RE: Seminole Electric Cooperative, Inc.
Seminole Generation Station, Putnam County, Fl.
Power Plant Certification PA78-10
Post Certification Amendment to Application

Pursuant to Section 403.5113 (1) (a), Florida Statutes, and Rule 62-17.205, Florida Administrative Code, please accept this letter and the attachments hereto as additional post-certification amendments to the Seminole Electric Cooperative, Inc. ("Seminole") Site Certification Application ("Application") for the Seminole Generating Station in Putnam County, Florida. These post-certification amendments address a proposed 4660 square foot concrete slab adjacent to the Unit 2 FGD scrubber modules and a proposed 1200 square foot awning (roof addition) to be added to the coal yard maintenance building.

Unit 2 FGD
Spill Containment Addition

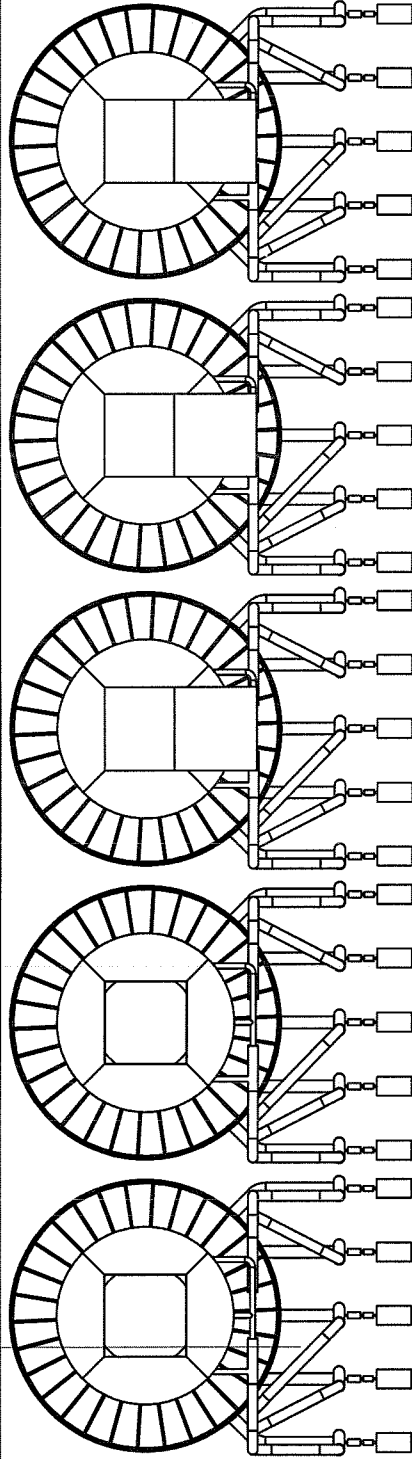
The proposed Unit 2 FGD scrubber concrete apron (see attached drawing no. 1) is required to minimize the possibility of discharges to groundwater from piping or other equipment that has historically caused abnormal event (upset) reporting to the DEP Northeast District office. This apron will allow the liquids from leaks to be captured and recycled back into the FGD system. This apron will not increase runoff or change the quality of water that enters the stormwater treatment system.

Hatched area is new concrete
Six channels will be cut in old curb for drainage
New concrete area will have a 12" curb surrounding
Unit 2 FGD System
Dimensions in feet

Coal Yard Maintenance
Building Roof Addition

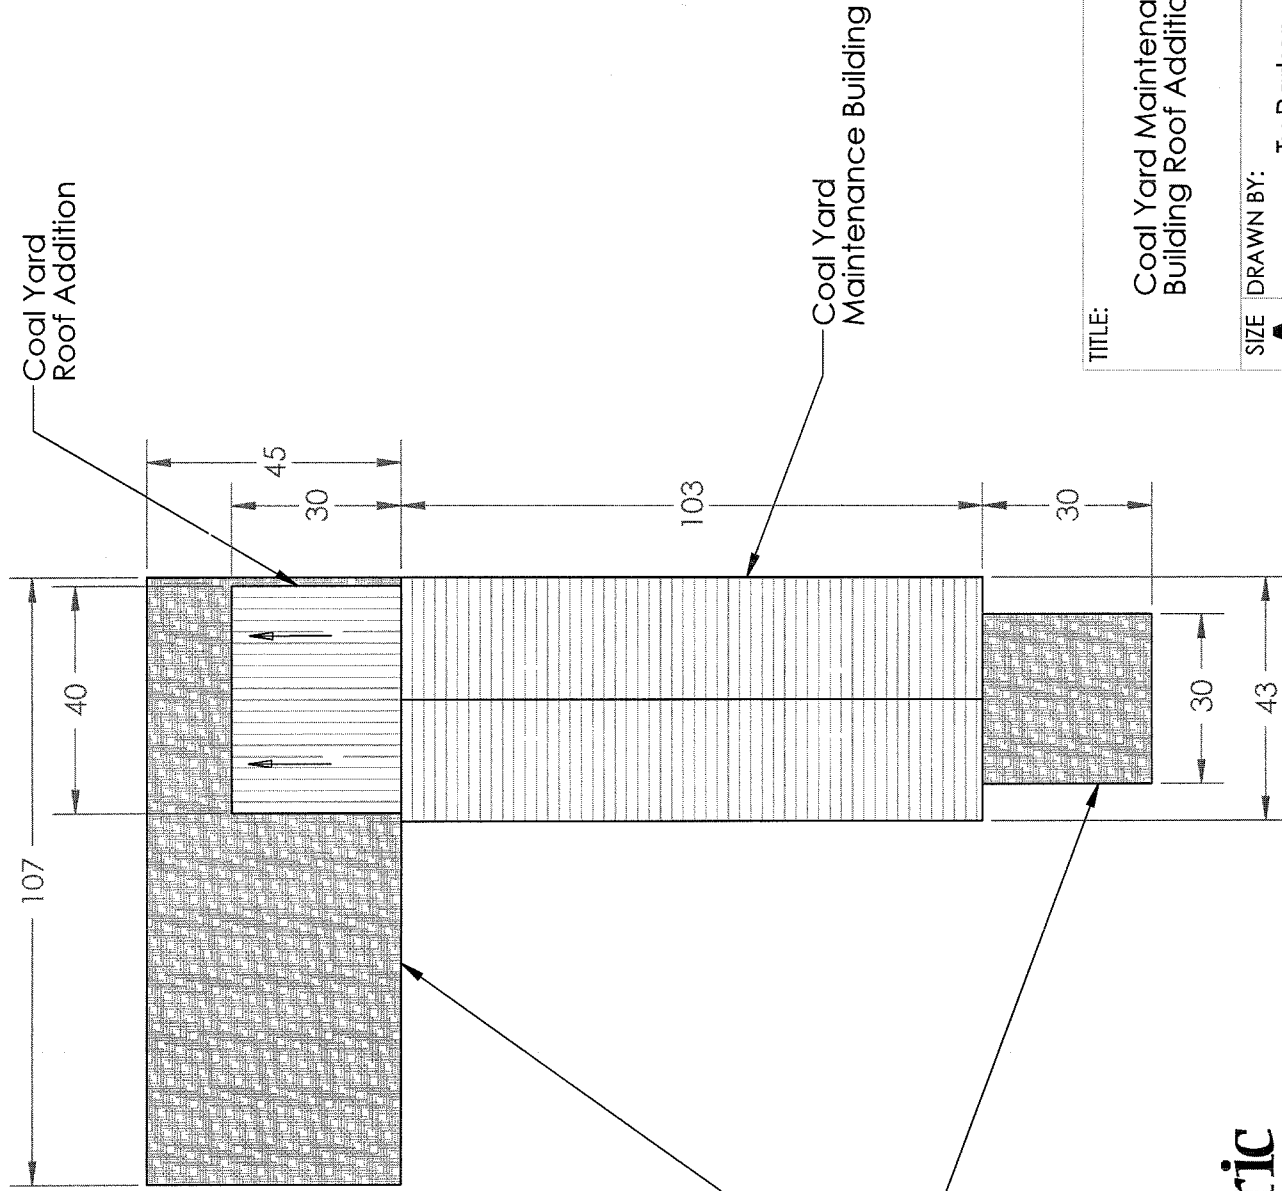
The proposed awning to be added to the coal yard maintenance building (see attached drawing no. 2) will allow heavy equipment to be sheltered from the weather. The area to be covered has an existing concrete slab covering the same area as the proposed awning. No changes in quantity to the impervious surface area is proposed since the area is already impervious and stormwater from this area is treated in the permitted stormwater system.

Dimensions in feet
Roof addition is built over
existing asphalt
